# Access Compliance Report

## Public Rights-of-Way (Curb Ramps)

Intersection ID: 49257	Main Street: BERRYBROOK_LN	Cross Street: SINGING_OAK_CT	Location: S
ADA ID: 8478717EFC4C	Ramp Type: PerpDiag	Initial Pass/Fail: Fail	Overall Compliance: No Severity Score: 26.25

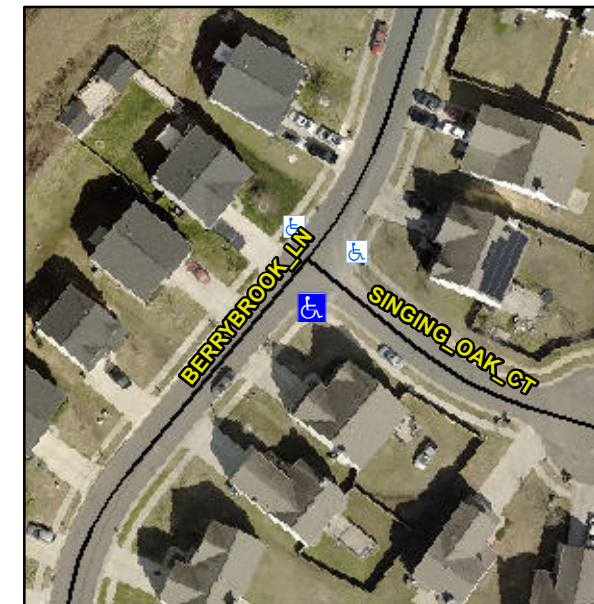
**Not Found, R304.2.2, R304.5.3**

Compliance	Description	Data	Compliance	Description	Data
N/A	Ramp Length (in)	47.0	No	Ramp Slope (%)	20.0
Yes	Ramp Width (in)	48.0	No	Ramp XSlope (%)	3.1
N/A	Flare Type LT	N/A	N/A	Flare Type RT	N/A
N/A	Flare Slope LT (%)	N/A	N/A	Flare Slope RT (%)	N/A
N/A	Flare Traversable LT?	N/A	N/A	Flare Traversable RT?	N/A
N/A	Landing Length (in)	N/A	N/A	DWS Provided?	N/A
N/A	Landing Width (in)	N/A	N/A	DWS Contrast?	N/A
N/A	Landing Slope (%)	N/A	N/A	DWS Length (in)	N/A
N/A	Landing X Slope (%)	N/A	N/A	DWS Full Width?	N/A
N/A	Landing Curb? (Y/N)	N/A	N/A	DWS Offset (in)	N/A
N/A	Shared Landing?	N/A			
N/A	Gutter Ponding?	N/A	N/A	Gutter Slope (%)	N/A
N/A	Gutter Lip Ht (in)	N/A	N/A	Gutter X Slope (%)	N/A
N/A	Painted X Walk1?	No	N/A	Painted X Walk2?	No
	X Walk 1 Direction	To NE		X Walk 2 Direction	To NW
N/A	X Walk 1 Width (in)	N/A	N/A	X Walk 2 Width (in)	N/A
	X Walk 1 Slope (%)	4.0		X Walk 2 Slope (%)	3.3
	X Walk 1 X Slope (%)	0.1		X Walk 2 X Slope (%)	5.6

**Remove & Replace Curb Ramp With Two New Directional Ramps or Equivalent.**
